Transport
Roads & Maritime
Services

LETTER REPORT

Environmental Design - Fauna Crossing Refinements

Nambucca Heads to Urunga Pacific Highway Upgrade

PLAN B - FAUNA CROSSING

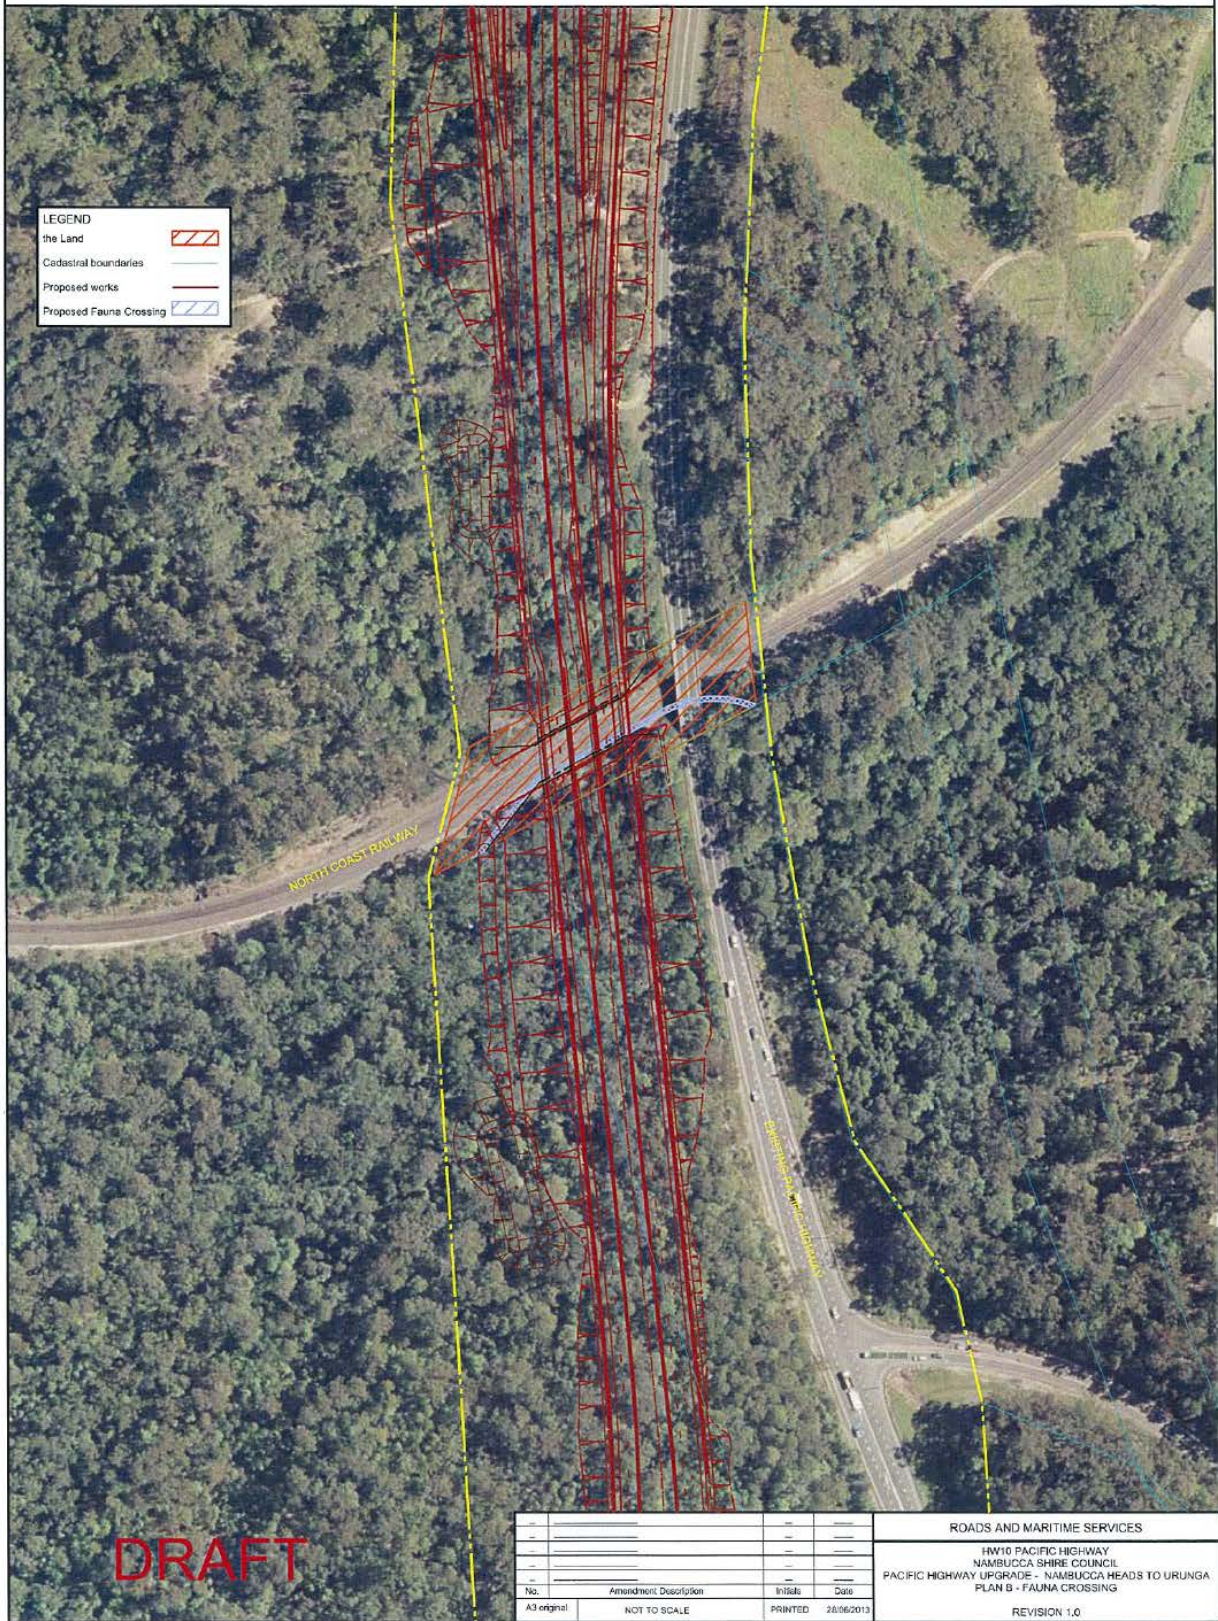
As discussed in our meeting on 28 June 2013, Roads and Maritime Services (RMS) and the Australian Rail Track Corporation (ARTC) have developed a modified licence to accommodate the introduction of a fauna crossing underneath the new and existing bridges over the North Coast Railway.

- The inclusion of Plan B showing the proposed new bridges and fauna crossing.
- Additional clauses to cover access and obstruction of the fauna crossing.
- The inclusion of the fauna crossing within the Infrastructure definition to ensure the licence for the fauna crossing is joined to the licence for the Pacific Highway twin bridges.
